**From:** [Eifion Bibby](#)  
**To:** [AwelyMor](#)  
**Subject:** Re-; Written Representation -Deadline -: 24th October 2022 - Proposed Development- Awel y Mor Offshore Wind Farm Scheme Our Clients:- Mr JB & Mrs E Evans [REDACTED] Our Ref:- AWE..EVA.J.-1-C  
**Date:** 24 October 2022 17:04:14  
**Attachments:** [Option Plan.pdf](#)  
**Importance:** High

RE: AWEL Y MÔR OFFSHORE WINDFARM PROJECT  
OUR CLIENT /INTERESTED PARTY :- MR JB & MRS E EVANS, [REDACTED]  
[REDACTED] REGISTRATION NO:- **20031650 RR-038**

**Scheme Name:**  
Awel y Môr Offshore Wind Farm

**Drawing Name:**  
Substation Option Plan

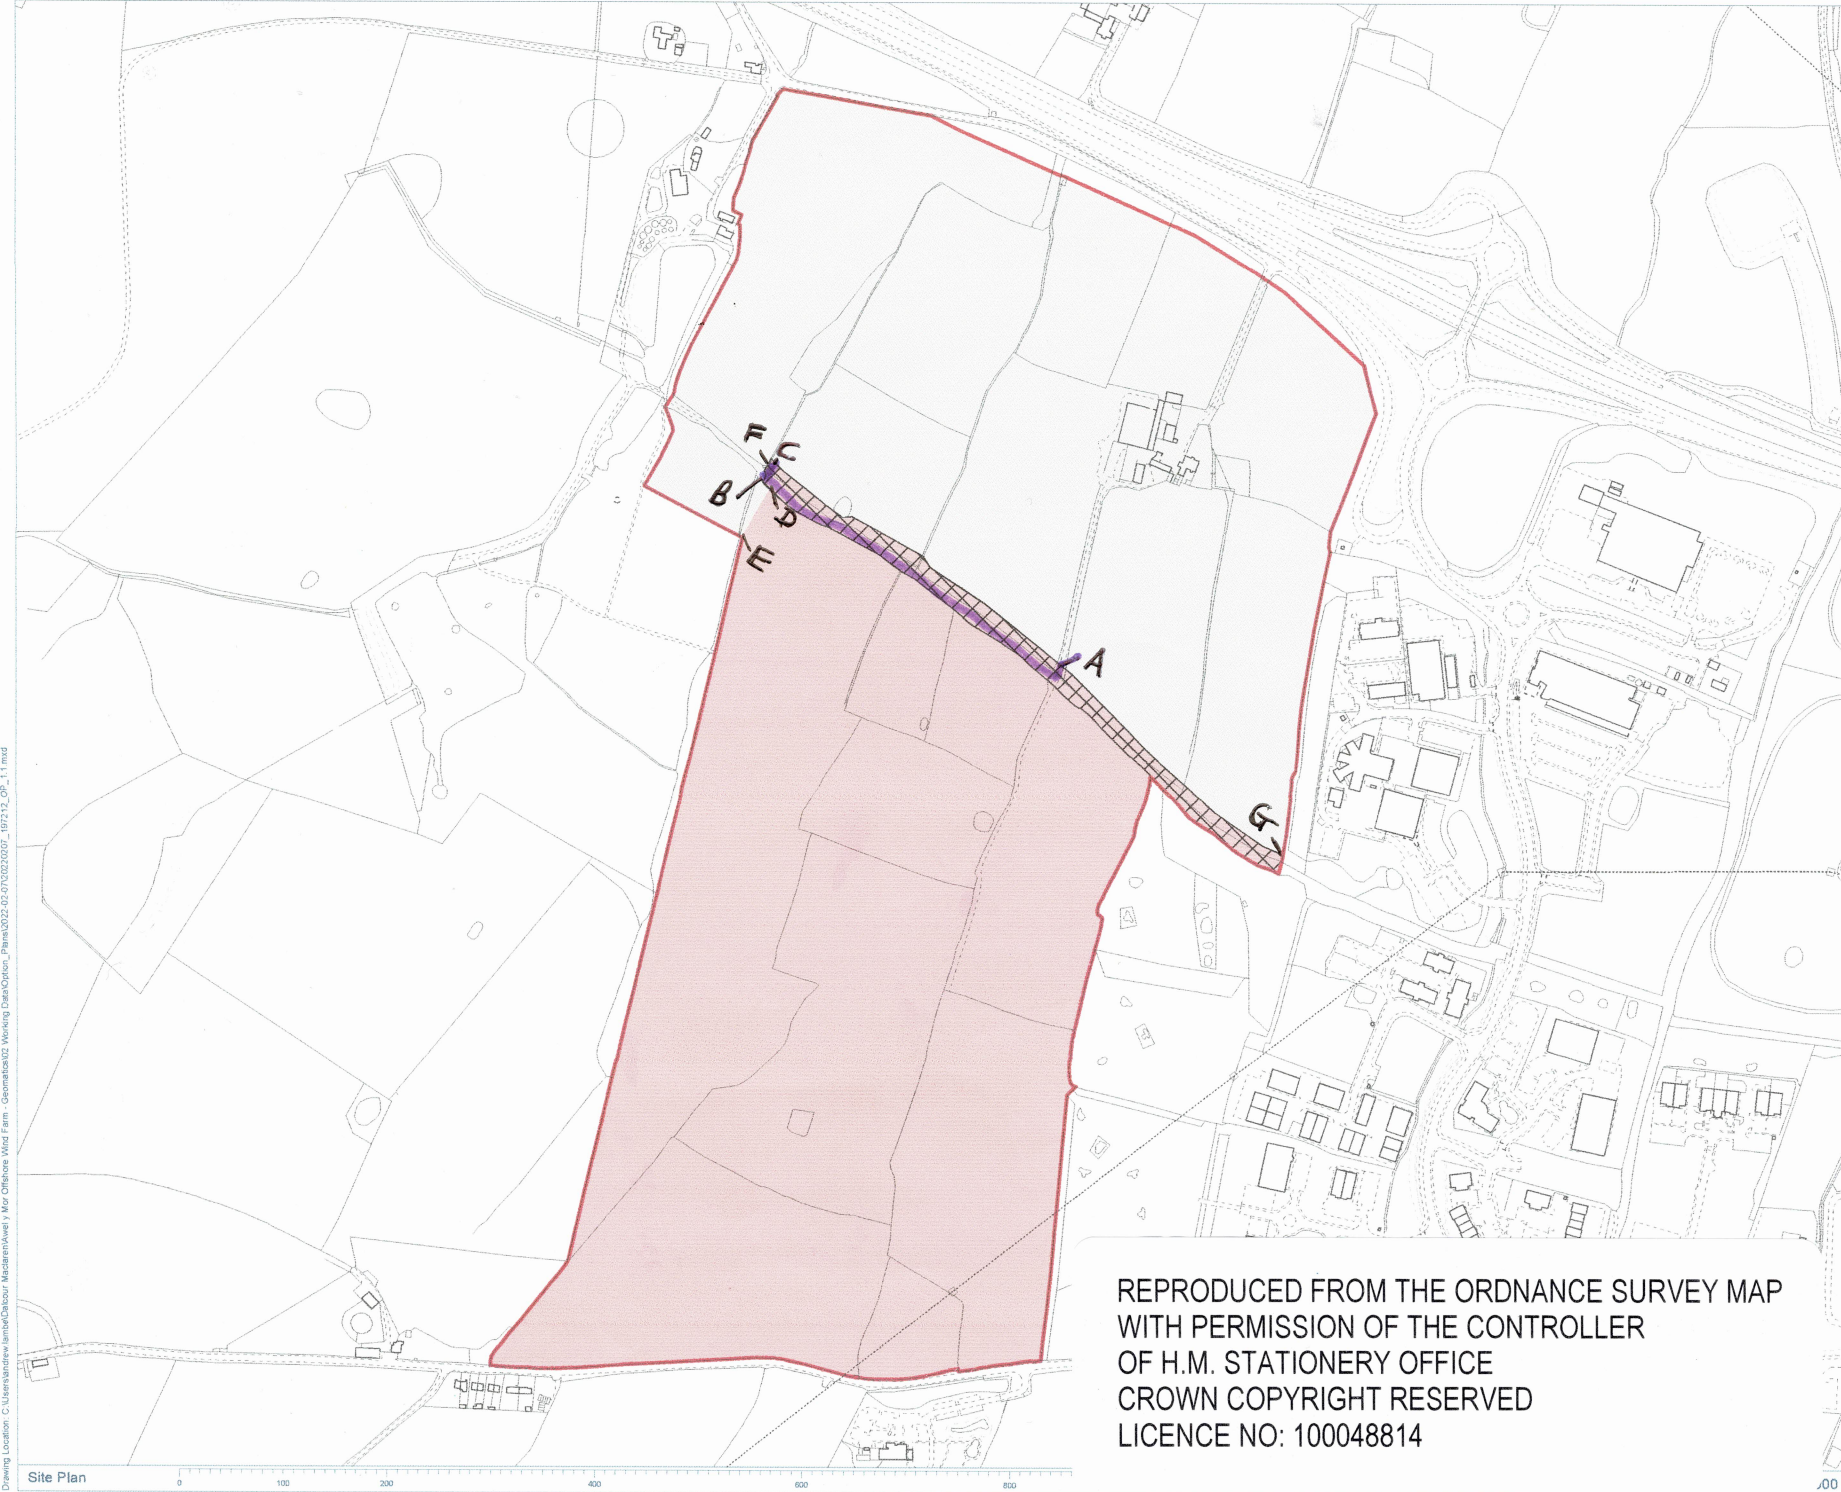
1. Whilst the principle for renewal energy requirements is accepted there is objection to the inevitable devastating impact that the proposed scheme will have on the viability of Faenol Bropor agricultural unit (being the 'property' shown for identification purposes only edged in red on the attached 'option plan') and accordingly the associated enterprise, given it is proposed that in excess of 54% ( up to 83.01acres /33.59 ha) of 'prime' agricultural land is to be acquired to locate a substation (together with 'mitigation/ bio diversity enhancement ') and a further 6% ( 9.55 Acres/3.86 ha) is earmarked for 'temporary occupation and use'( potentially ,it is currently anticipated ,up to 2030 ) in respect of the intended cable corridor and outfall pipe (in aggregate extending to over 60% of the farm).

5. As regards to damaging the viability of retained land (**being all the property excluding that tinted red on the accompanying 'option plan'**) , laying infrastructure (such as cables) at a depth of 0.75m below ground level will limit the ability to effectively subsoil and/or mole-plough ,when needed to address compaction to maintain natural drainage .Such apparatus should therefore be installed at a minimum of 0.9 m below surface level (to accord with, what is regarded as 'established standard practice with such schemes ' ) to mitigate impact on productive capacity . Furthermore , where excavations apply it is considered imperative that topsoil , subsoil, and the boulder clay are all kept separate within our client's land and are reinstated in sequence (of boulder clay followed by sub soil and then topsoil) with the aim of protecting the structure of the soil strata.

- b) a 4m gated access to apply from the right of way extending from point C to the residual severed parcel to the south of point B ,as shown for identification purposes only , on the accompanying Option Plan .

10. Detailed provisions need to be included in the Development Consent Order as to the applicant (and assigns ) being responsible for the installation (where appropriate) and maintenance of all boundaries between the area(s) proposed to be acquired (as shown tinted in red on the accompanying option plan) and Faenol Bropor retained property to a livestock (cattle and sheep) proof standard (to our clients reasonable requirements) .

11. Provision is required to be contained within the Development Consent Order for a right of way for all purposes , for the benefit of Faenol Bropor retained property , from A-B-C as shown ,for identification purposes only ,on the accompanying 'option Plan' (in order to mitigate access disruption for farming operations).
